**Application Reference No. 2023/62/91491/W**  
**Proposed Development at Prickleden Mills, Woodhead Road, Holmfirth, HD9 2JU**  
**Impact on 29 Woodhead Road, Homefirth, HD9 2JU**

**Application Details** Erection of 61 age-restricted apartments with ancillary accommodation including separate residents lounge and manager facilities and associated external works, including the erection of access bridge and riverside walk featuring two pedestrian bridges (within a Conservation Area)

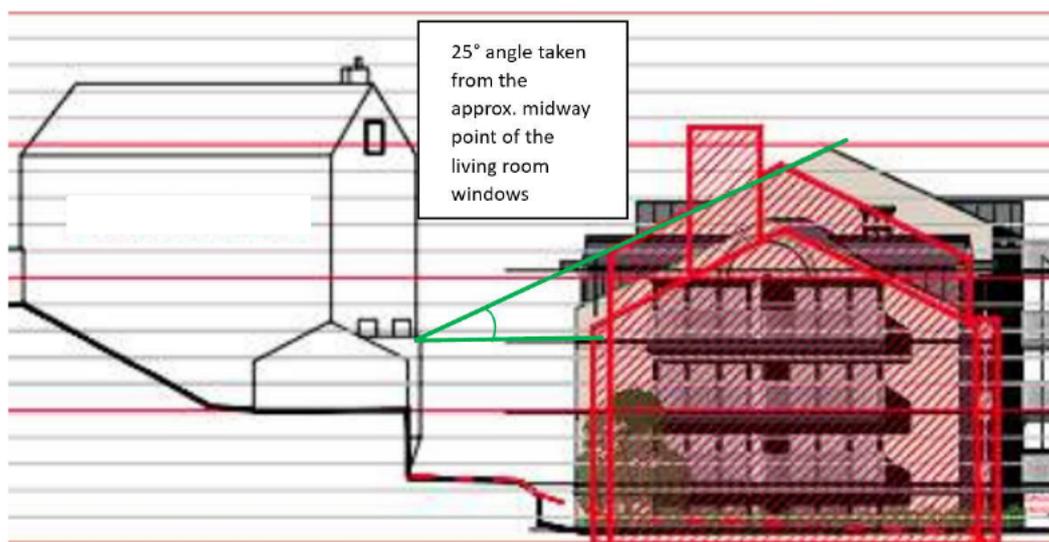
The application drawings for the proposed development at Prickleden Mills partially show the relationship to the living room windows at . We have plotted the approximate position of the centre of the living room windows on the proposed elevation drawing contained within the applicant's Design and Access Statement.

It is evident from the drawing below that the proposed development does not satisfy the 25° test. The 25° angle, drawn in green, extends through an area of the proposed development at Prickleden Mills.

Breaching the preliminary 25° test signifies that further detailed tests are needed. We would therefore expect the council to require the applicant to carry out an assessment in accordance with the BRE guide.

The assessment should include the following tests:

- Vertical Sky Component
- Daylight Distribution
- Sunlight
- Overshadowing
